Model: General RTB	Date: 26-Apr-11	No.: RGene044
--------------------	-----------------	---------------

Subject: New Bluetooth Option		Prepared by: N.Yoshida	
From: 1st Overseas Tech Support Sec., 1st PQM Dept.			
Classification:	<input type="checkbox"/> Troubleshooting	<input type="checkbox"/> Part information	<input checked="" type="checkbox"/> Action required
	<input type="checkbox"/> Mechanical	<input type="checkbox"/> Electrical	<input type="checkbox"/> Service manual revision
	<input type="checkbox"/> Paper path	<input type="checkbox"/> Transmit/receive	<input type="checkbox"/> Retrofit information
	<input type="checkbox"/> Product Safety	<input type="checkbox"/> Other ()	<input checked="" type="checkbox"/> Tier 2

Important Information on the Release of the optional Bluetooth Interface Unit Type D

Model name: Bluetooth Interface Unite Type D
Machine code: D566-01
EDP code: 415818

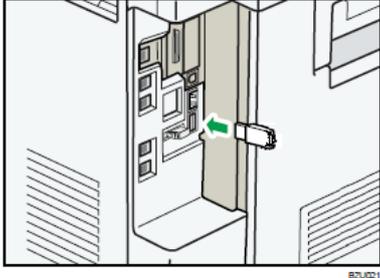
- In March 2011, production began on the **Bluetooth Interface Unit Type D**, a USB version of the existing CF card type. The changeover from the CF card type to USB type begins from the AT/AP-C2.5.
- To support the new option, the System Firmware was modified. For a list of the target models and supported System software for each, see the “Target Models, Firmware” table below.
- For the specifications of this option, see the Operating Instructions.

- Make sure the System firmware has been updated to the following versions or newer. Then, have the user do the procedure shown on the next page.
- Make sure to hand the customer all of the Operating Instructions (manuals) bundled together with the Bluetooth Interface Option.

Model	Code	System firmware	Applied to the production line
01.	AP-C2.5	D088/D089	3.00	2011 March
02.	AT-C2.5	D086/D087	2.00	2011 March
03.	Z-C1	M022/M024/ M026/M028	2.00	2011 March
04.	Di-C1.5	D104/D106	2.00	2011 April
05.	Sh-MF1	M052/M053/M054	TBA	TBA

Note: If you do not update the System firmware to these versions or newer, the following error message will appear:
 "Incompatible USB device has been connected. Check the USB device"
